Item Name: Fwd Crosstube - High 407

WORK ORDER NON-CONFORMANCE / UPDATE

DRAWING NO. D407-667-145	TITLE CROSSTUBE ASS'Y (407 HIGH FWD)	REV. C	DART AEROSPACE LTD ENGINEERING ORDER		D.E.O. NO. D407-667-145-C-1	SHEET NO. SHEET 1 OF 1	SCALE NTS
DRAWN <i>97</i>	CHECKED <i>ASS</i>	MFG. APPR. <i>AB</i>	APPROVED <i>MD</i>		DE APPR. <i>##</i>		
DATE 11.07.15	DATE 11.07.22	DATE 11.07.22	DATE 11/07/22		DATE 11.07.21

DRAWING NO. D407-667-145	TITLE CROSSTUBE ASS'Y (407 HIGH FWD)	REV. C	DART AEROSPACE LTD ENGINEERING ORDER		D.E.O. NO. D407-667-145-C-2	SHEET NO. SHEET 1 OF 1	SCALE NTS
DRAWN AJS	CHECKED	MFG. APPR.	APPROVED		DE APPR.		
DATE 12.08.02	DATE 12.08.02	DATE 12.08.02	DATE 12.08.02		DATE 12.08.02

DETAIL P
BONDING STRAP INSTALLATION 2 PL

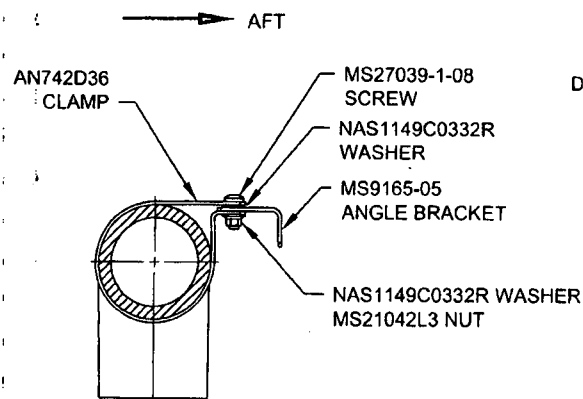
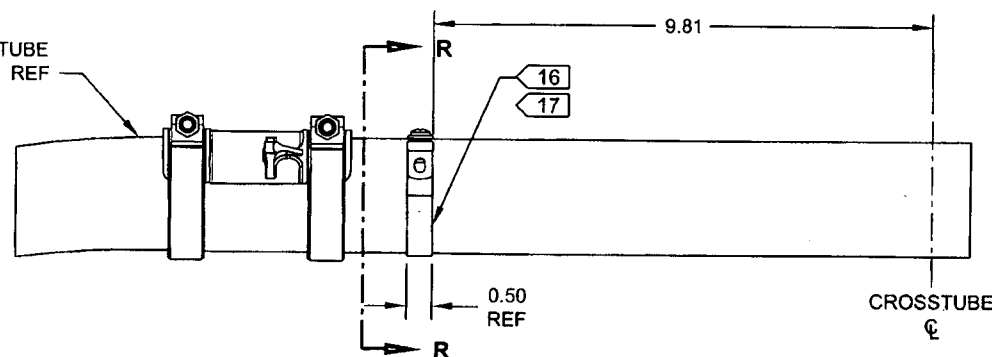
ADD ELECTRICAL GROUNDING STRAP

ITEM	QTY -145	PART NUMBER	DESCRIPTION
1	X	D407-667-145	CROSSTUBE ASSEMBLY (407 HIGH FWD)
10	2	AN742D36	CLAMP
11	2	MS9165-05	ANGLE BRACKET
12	2	MS21042L3	NUT (OR MS21042-3)
13	2	MS27039-1-08	SCREW
14	4	NAS1149C0332R	WASHER (OR AN960C10L)
